Certificate of Appropriateness

501 W. Historic Mitchell Street, Mitchell Street Historic District

Replace the outer one wythe of exterior brick on the subject building with a new brick that closely resembles the existing cream brick in terms of color and finish.

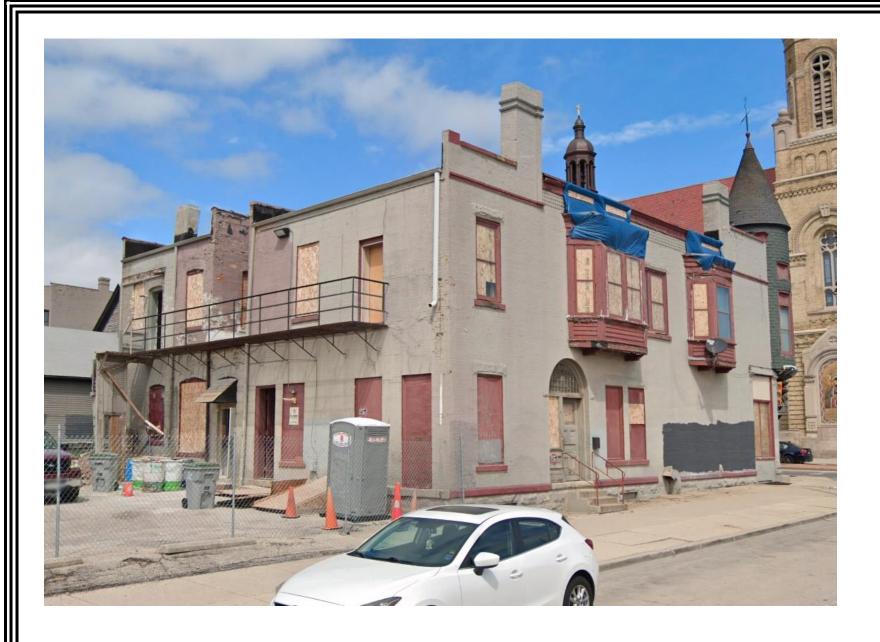
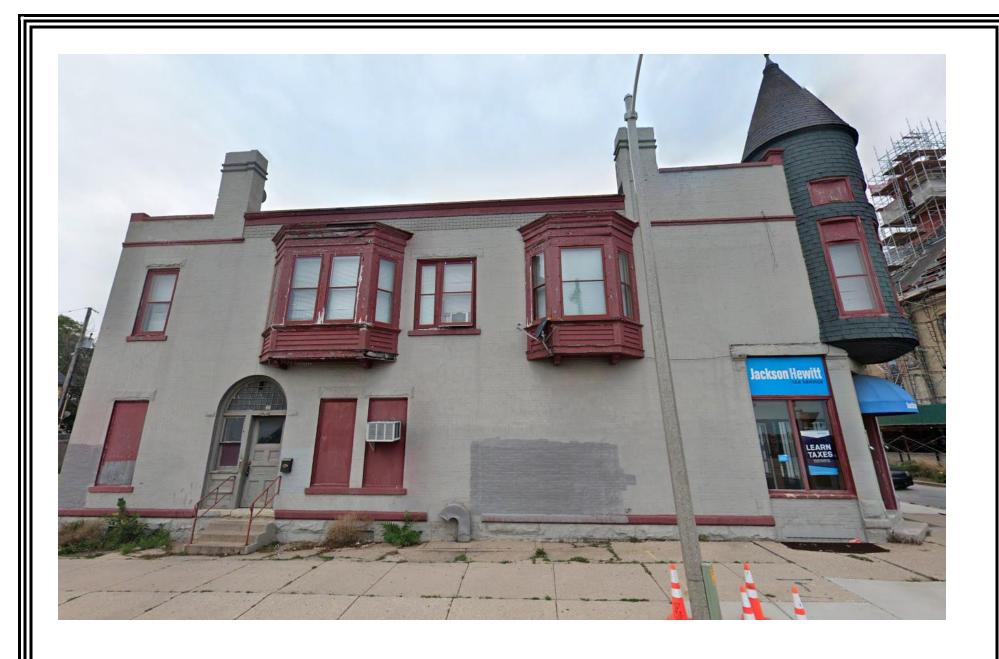
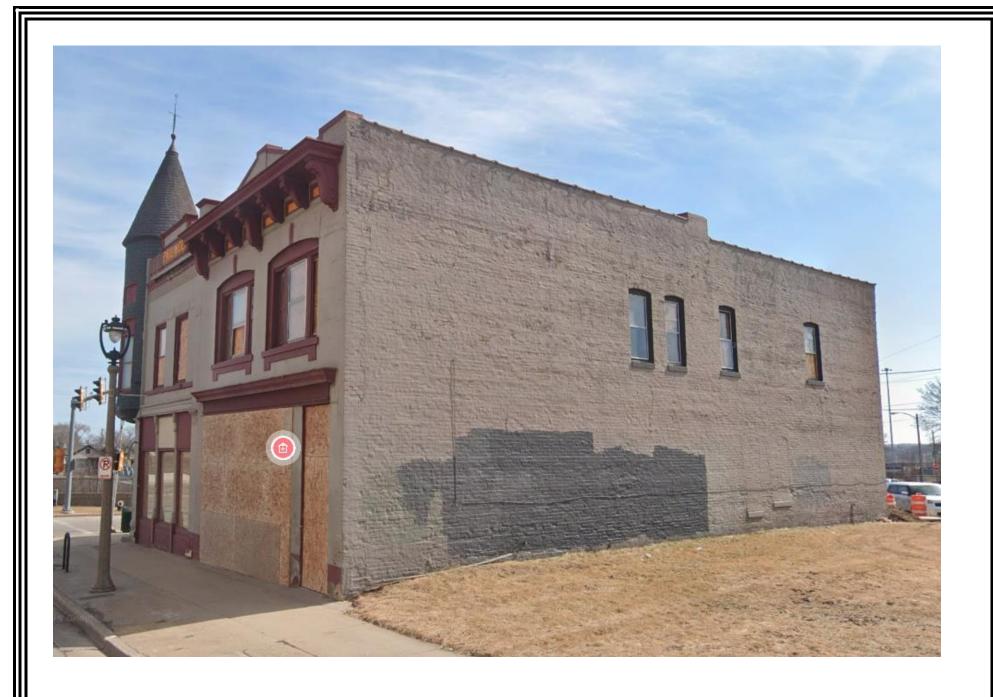
Replacement brick circled. Brick to match as closely as possible the historic cream brick.
